Adding charts comments against 802.3cu D2.1 #10, 11 (updated)

May 26, 2020 Interim Teleconference

IEEE P802.3cu 100 Gb/s and 400 Gb/s over SMF at 100 Gb/s per Wavelength Task Force

Figure 140-2a—Illustration of $\text{OMA}_{\text{outer}} (\text{max})$ and $\text{OMA}_{\text{outer}} (\text{min})$ versus TDECQ for 100GBASE-DR, 100GBASE-FR1 and 100GBASE-LR1

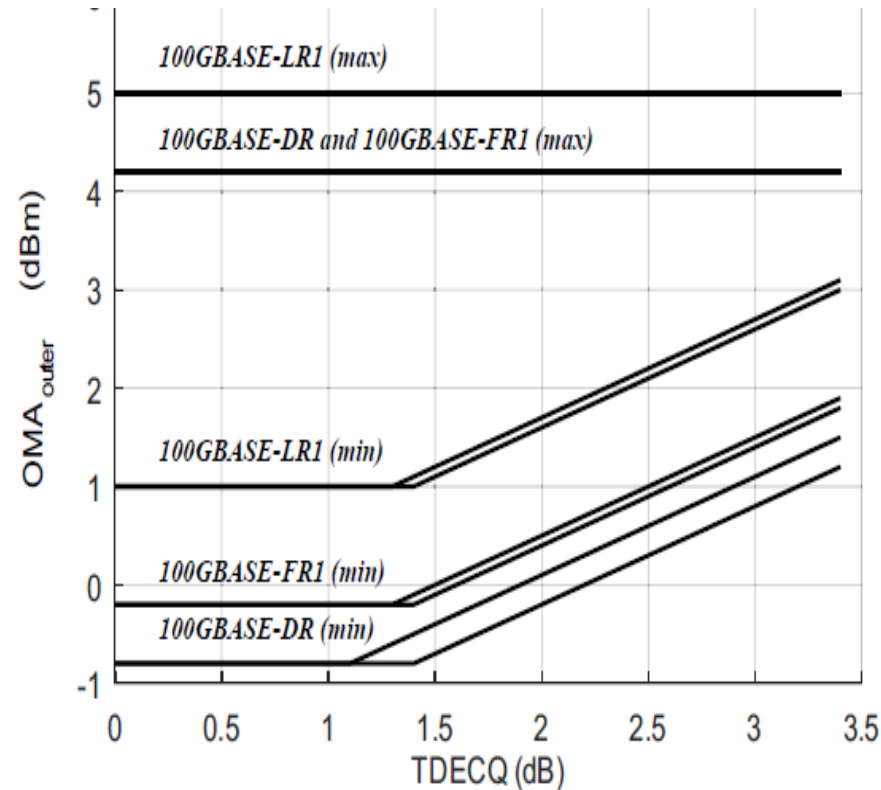
Insert the new Figure 140-2a and text as below:

The values for $\text{OMA}_{\text{outer}} (\text{min})$ in Table 140-6 vary with TDECQ. The relationships are illustrated in Table 140-2a along with the values for $\text{OMA}_{\text{outer}} (\text{max})$.

Figure 140-2b—Illustration of receiver sensitivity (OMA_{outer}) (max) for 100GBASE-DR, 100GBASE-FR1 and 100GBASE-LR1.

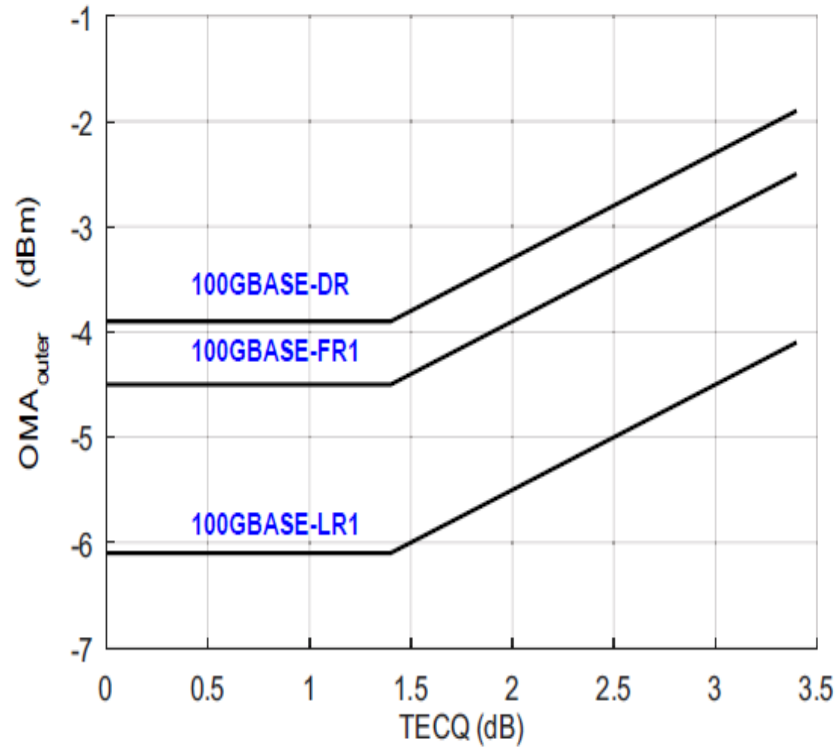
Insert the new figure 140-2b and introductory text as below:

The values for receiver sensitivity (OMA_{outer}) (max) in Table 140-7 vary depending on the value of TECQ for the test source used for measurement. Figure 140-2b illustrates this.

Figure 140–2c—Illustrative link power budget for 100GBASE-FR1

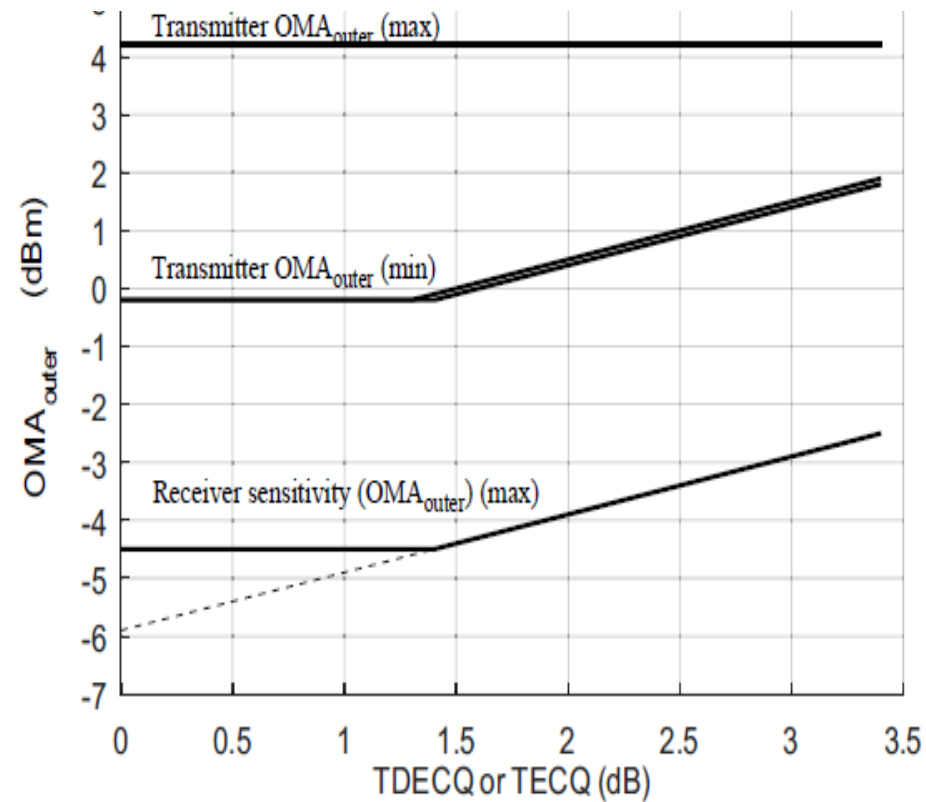
Insert new figure 140-2c and text as below:

The illustrative link power budget values in Table 140–8 are shown graphically for 100GBASE-FR1 in Table 140–2c.
